REMARKS

Application No.: 09/901,635
Examiner: Suhan NI
Art Unit: 2643

Fig. 35

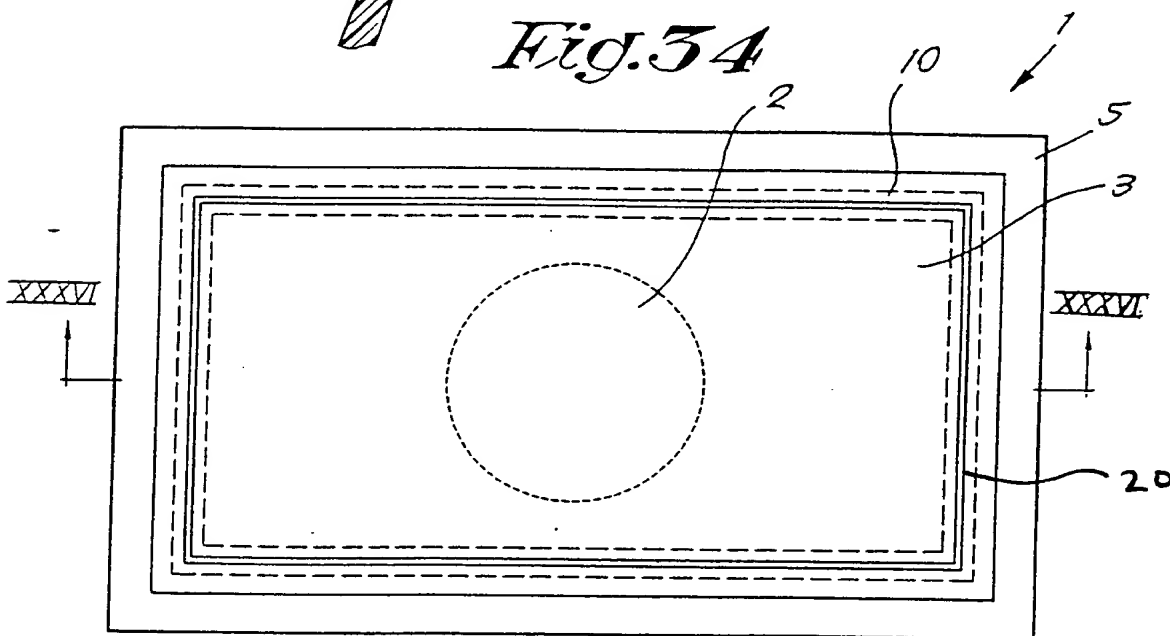
FIGS. 35 and 36 have been amended to denote the "passageway" as recited in claim 13. The passageway is denoted by reference numeral --20--. Acceptance of the amendment to the drawings is respectfully requested.

Fig. 36

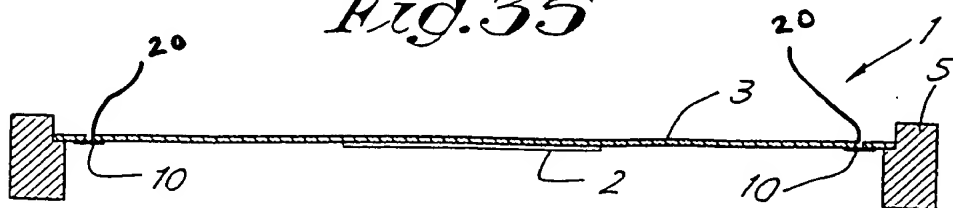
The specification has been amended to correct a typographical error that was identified during the course of review. In addition, the specification has been amended to reflect the amendment to claim 13 and was amended in accordance with the illustration of FIG. 36. Applicant submits that no new matter has been added as a result of this amendment. Acceptance of the amendment to the specification is respectfully requested.
